Project T10/1760-D

Revision 14
28 January 2008

Information technology - Serial Attached SCSI - 2 (SAS-2)

Summary of Comments on Serial Attached SCSI - 2 (SAS-2) Standard

Figure 10 — SAS Domain class diagram

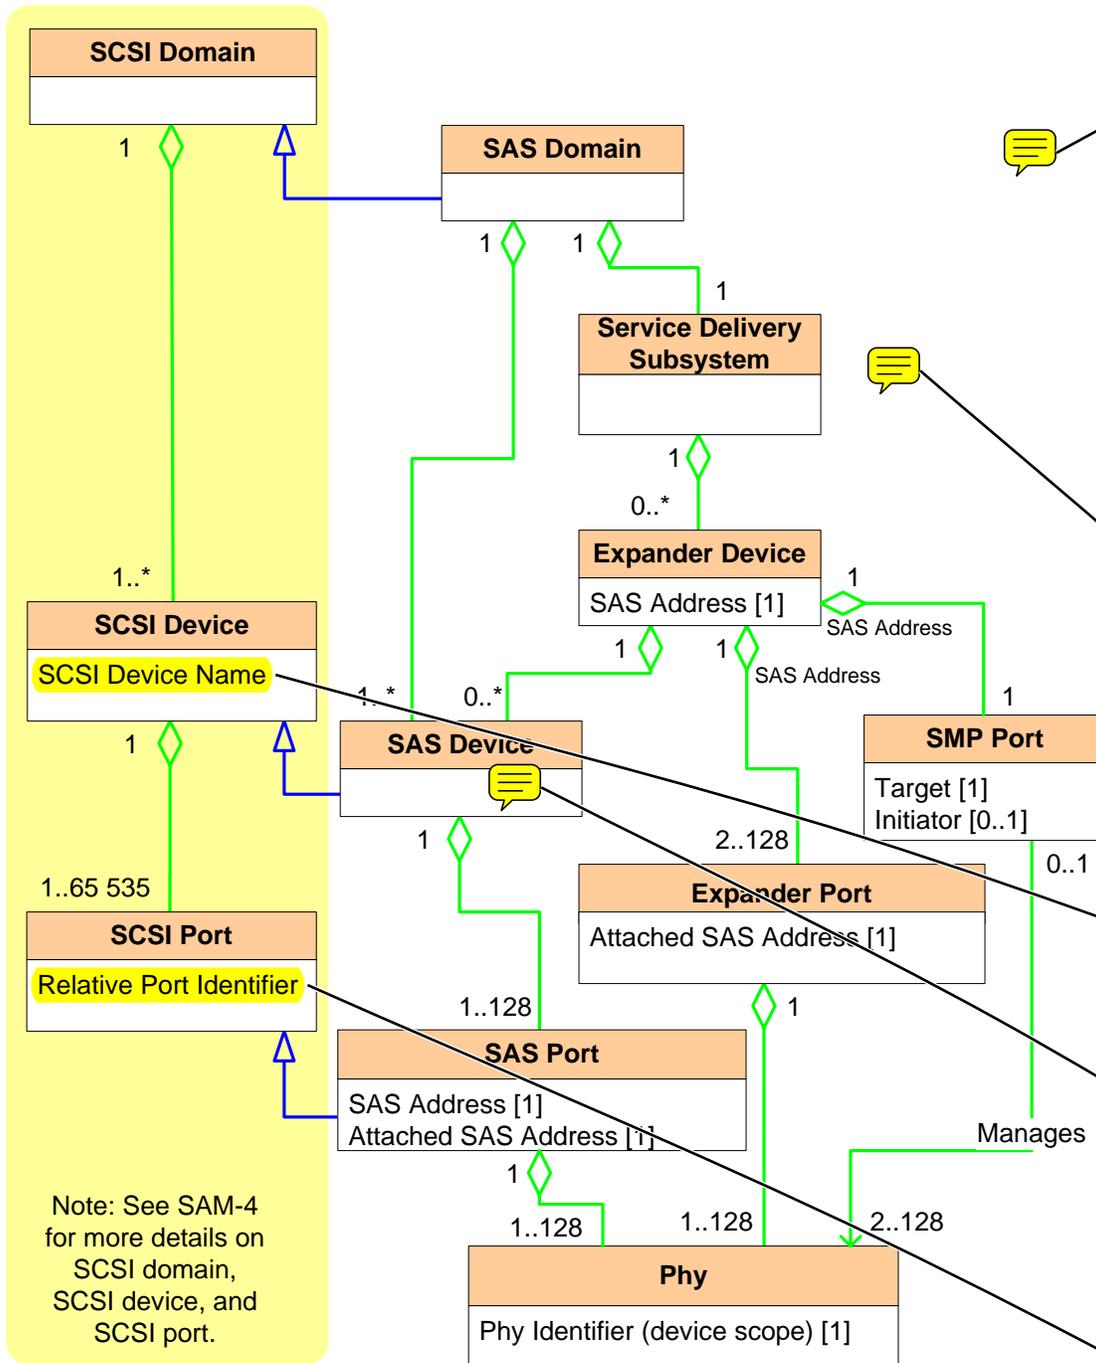
figure 10: changed 1..128 to 1..255

figure 10: changed 2.. to 2..255

Figure 16 — Port class diagram

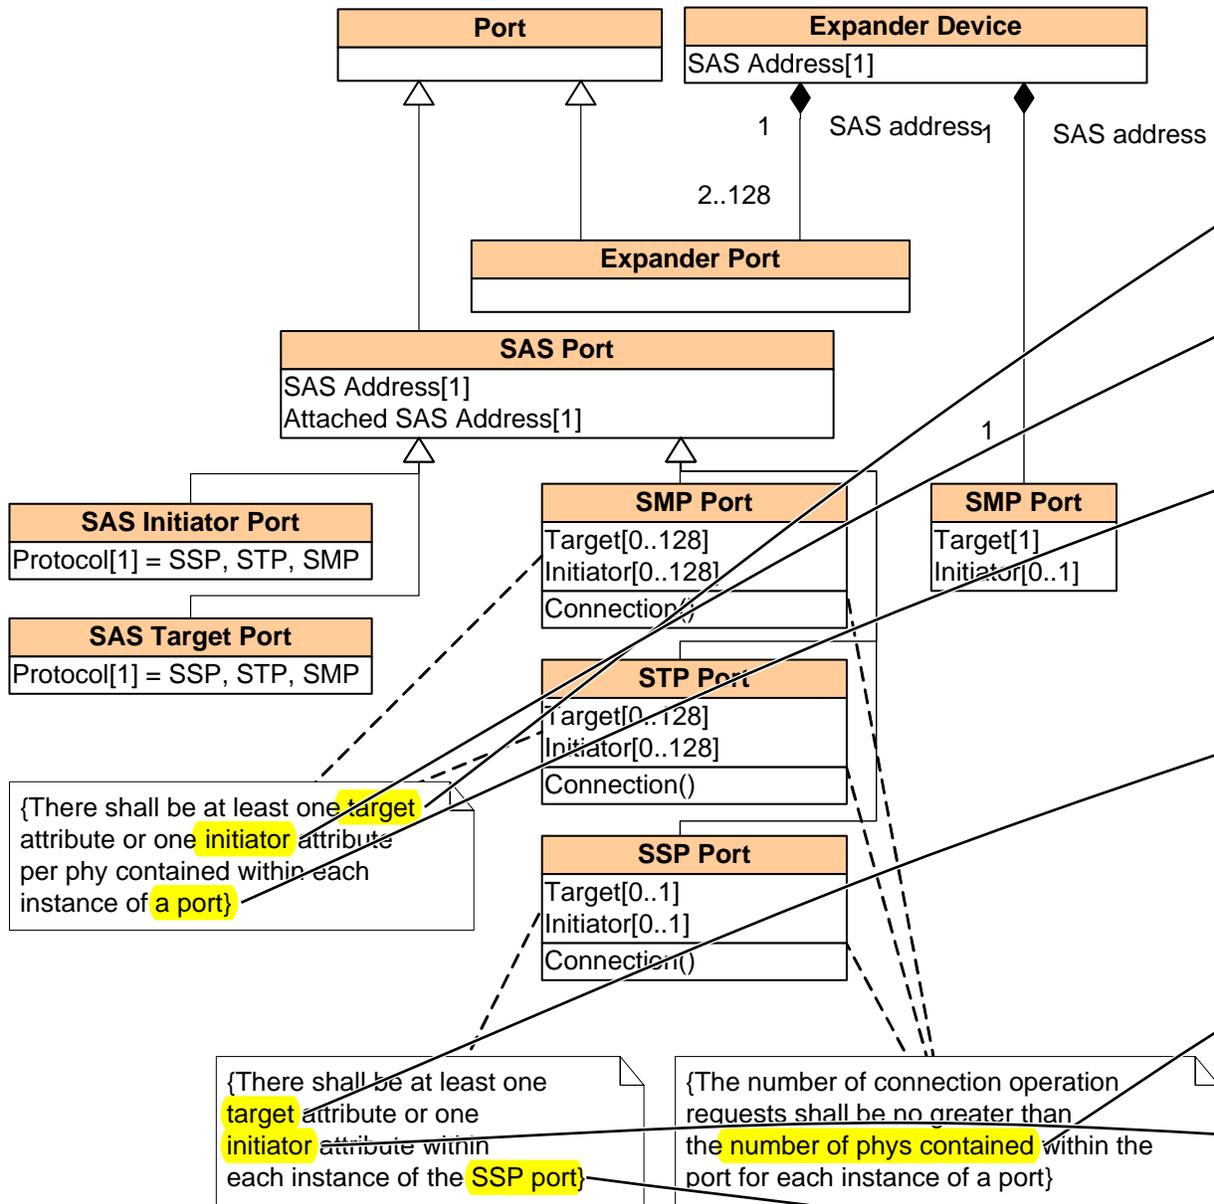
figure 16: changed [0..128] to [0..255] (zero to 255 possible phys)

figure 16: changed 2..128 to 2..255

Should be << detail is not shown. However, each port

Figure 28 — Multiple connections on wide ports

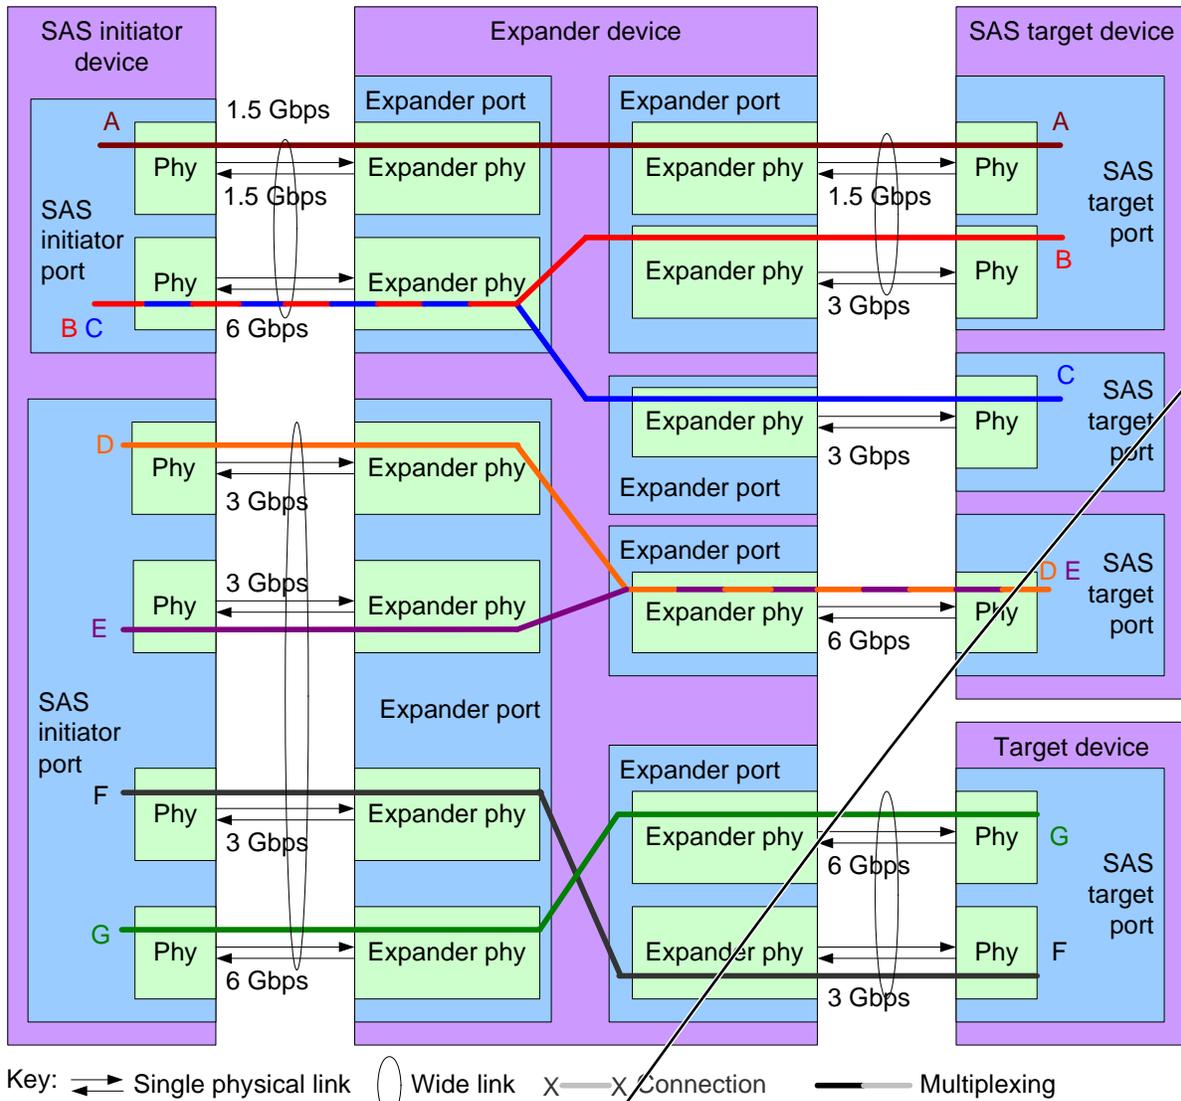
This seems to illustrate one SAS initiator port with connections to multiple SAS target ports. D and E illustrates connection to multiple initiator phys, but they might still be the same initiator port.

Figure 38 — State machines and SAS Device classes

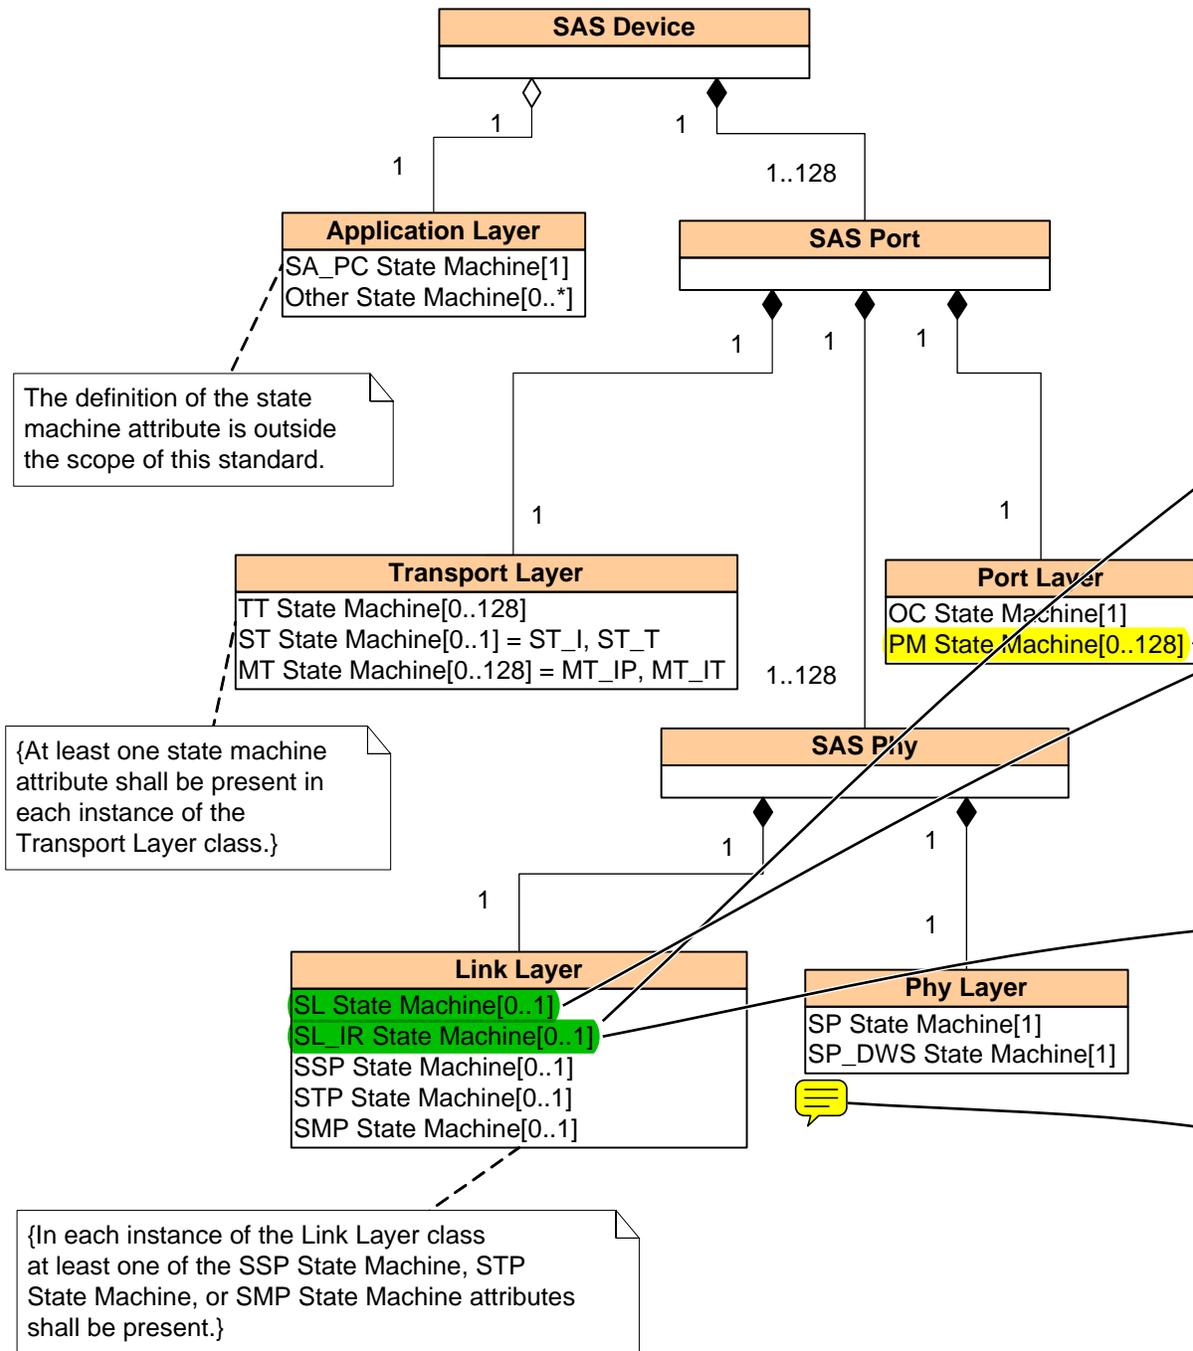
also figure 38: 0..128 to 0..255

also figure 38: 1..128 to 1..255

Figure 40 — Reset terminology

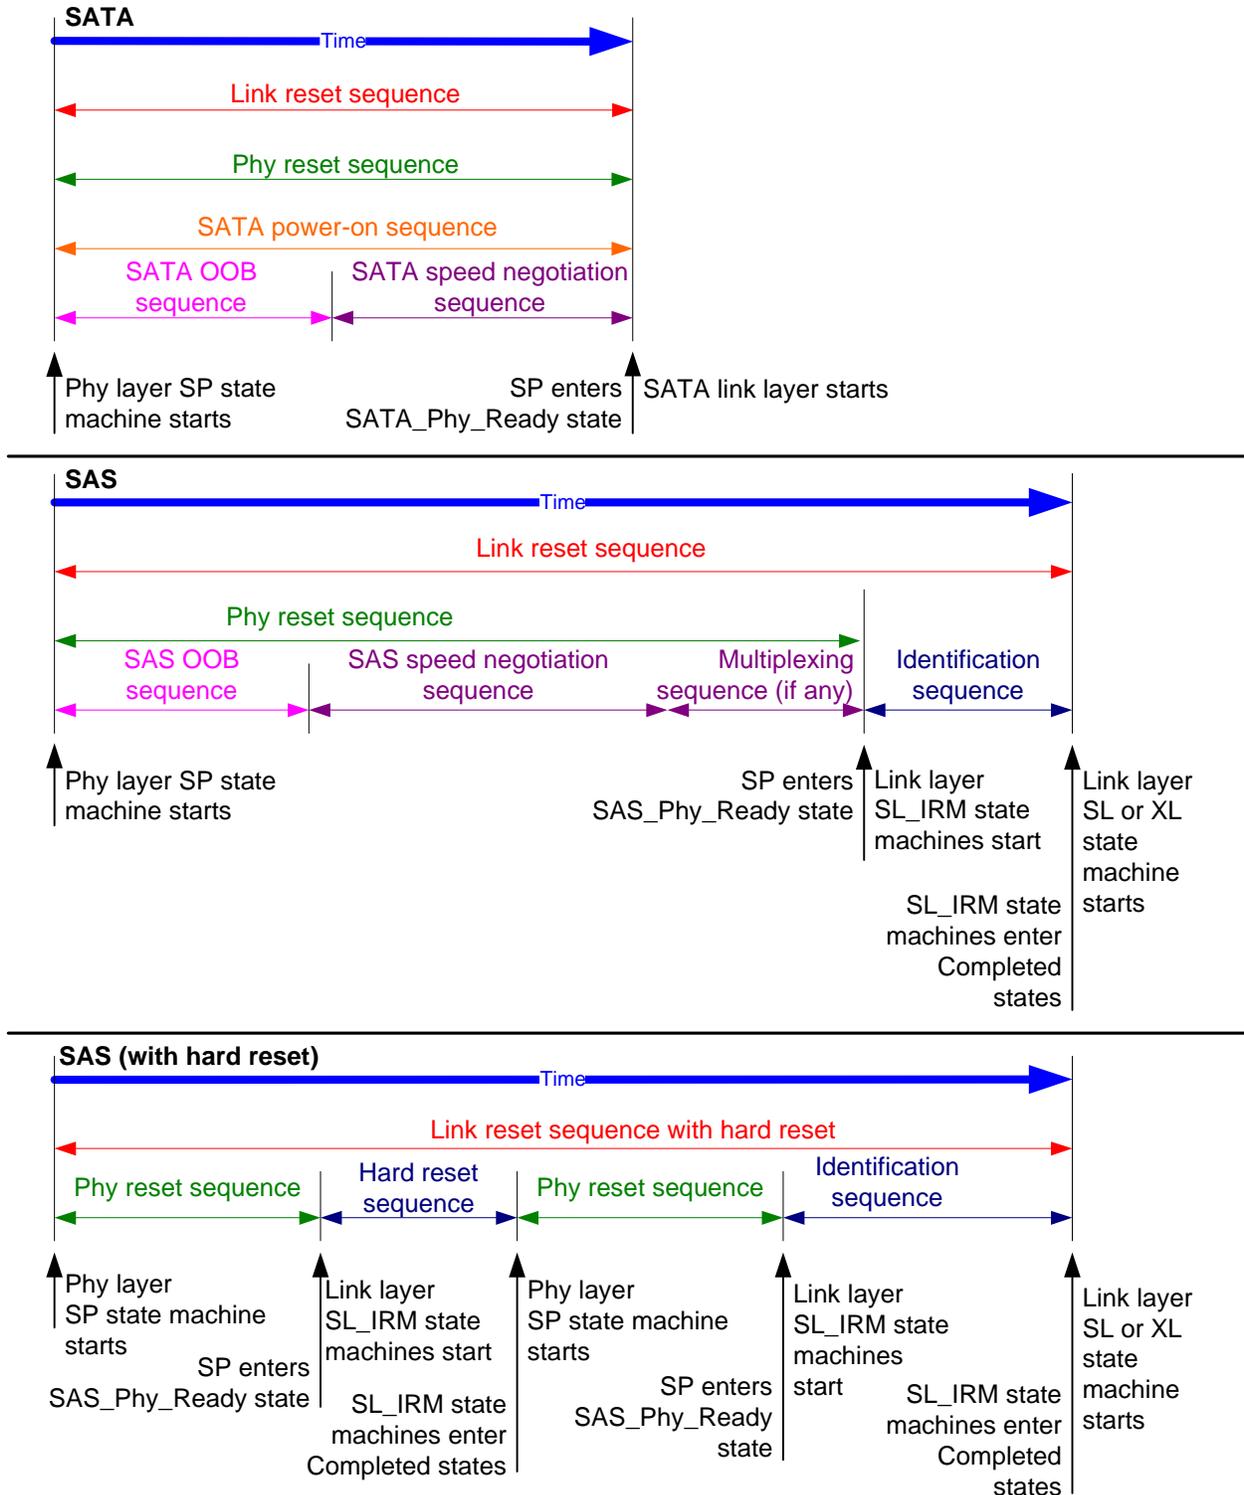
This figure does not show an SMP phy and associated link layer state machines below the SMP Port since figure 16 does not do so. If the expander allows more than one connection at a time to its SMP target port, then it's effectively a wide SMP port and has multiple phys and link layers. If it only allows one at a time, then it's effectively a narrow SMP port and only has one phy and link layer.

Figure 50 — Expander route index order example

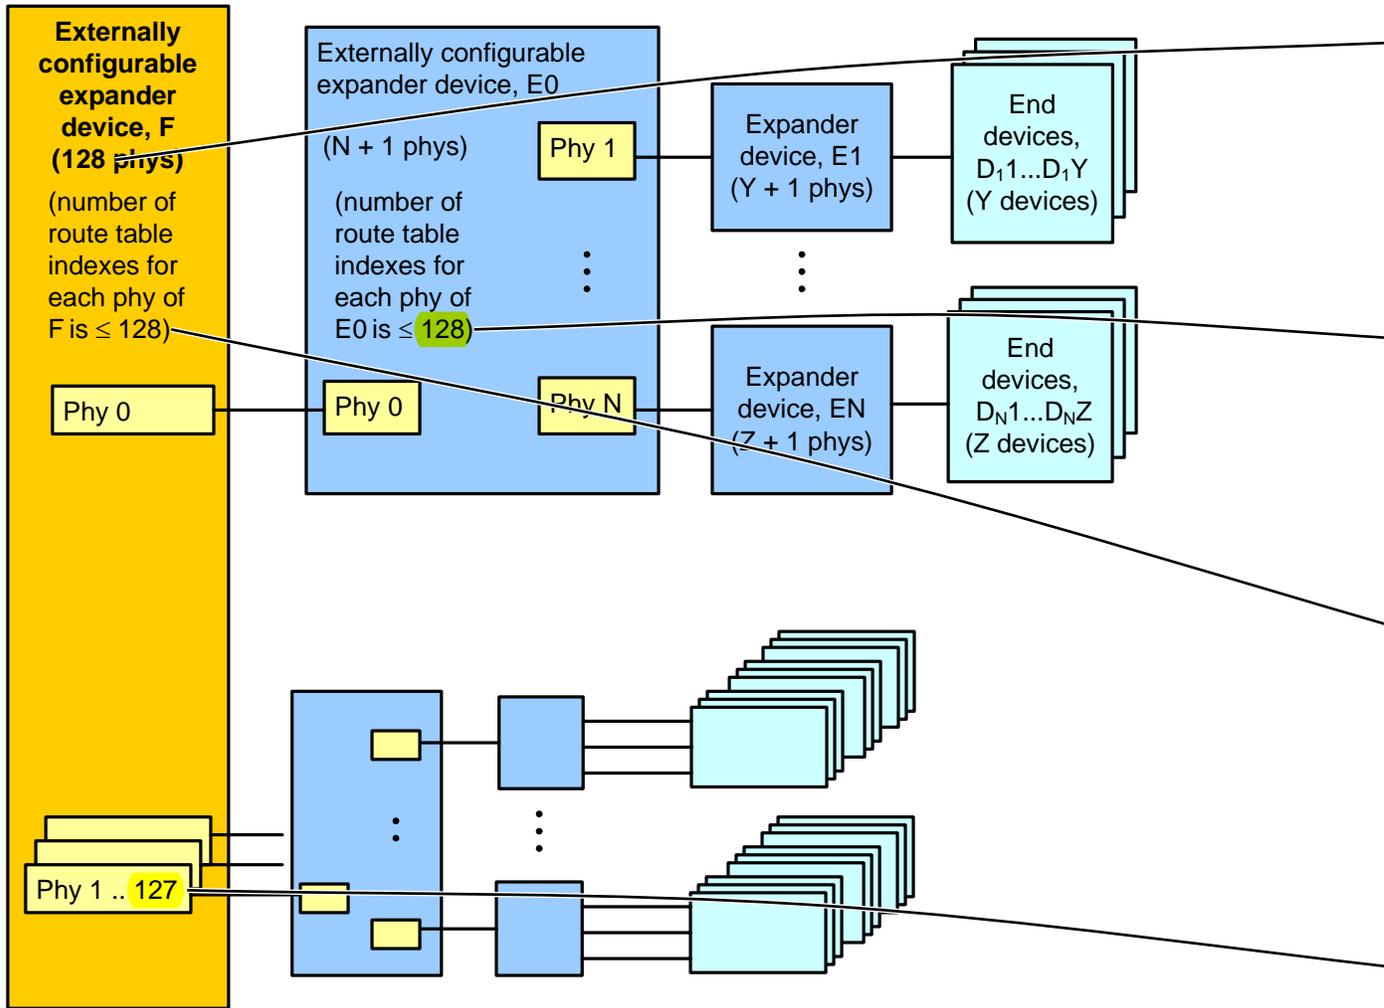
in figure 50, not table 50: 128 to 255, deleted two unnecessary sentences

Figure 87 — SAS internal symmetric cable assembly - SAS 4i to Mini SAS 4i with vendor-specific sidebands

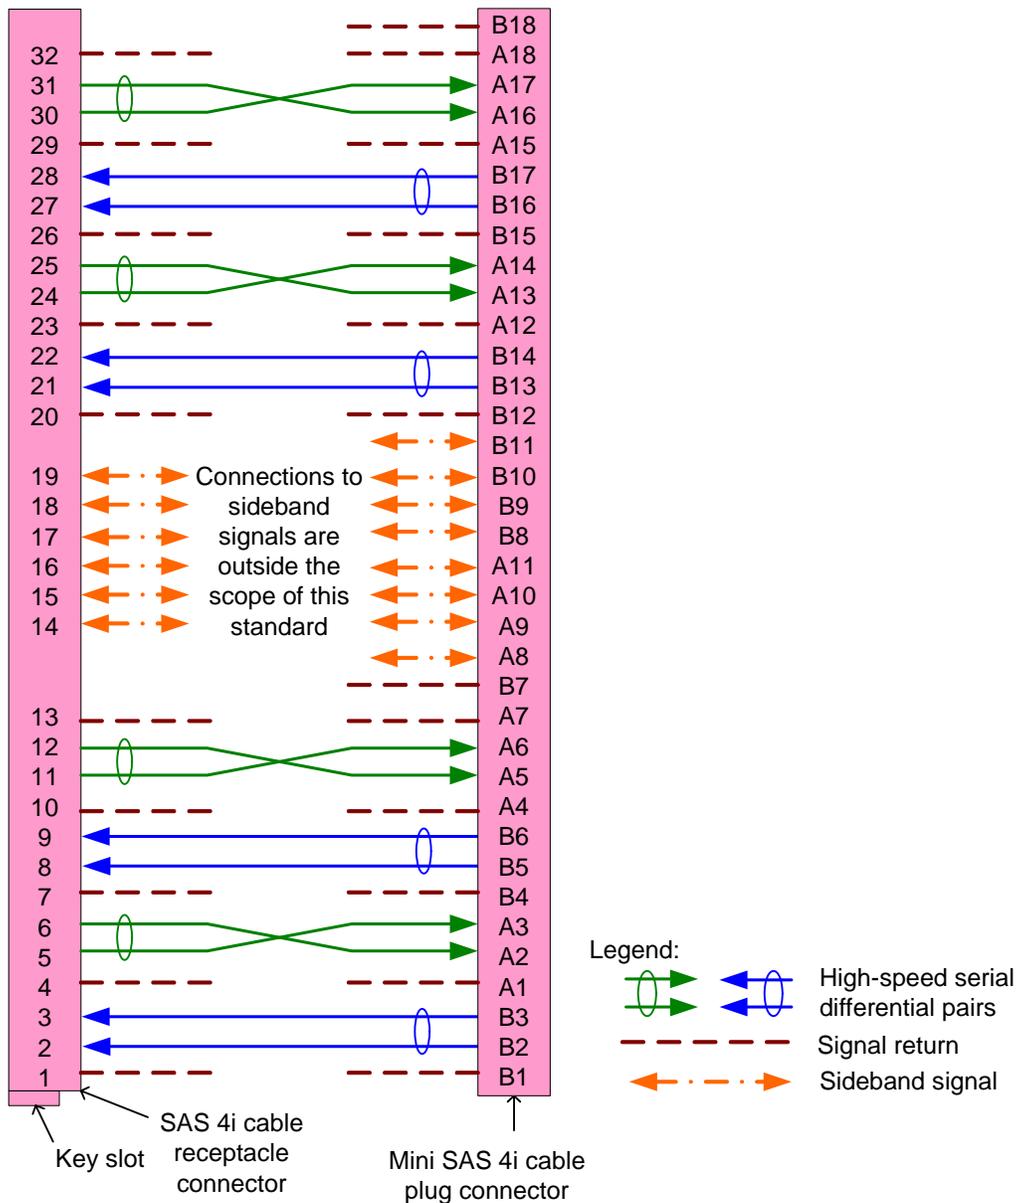
throughout this section, to make it clearer that these rules only apply to the connector in figure 87
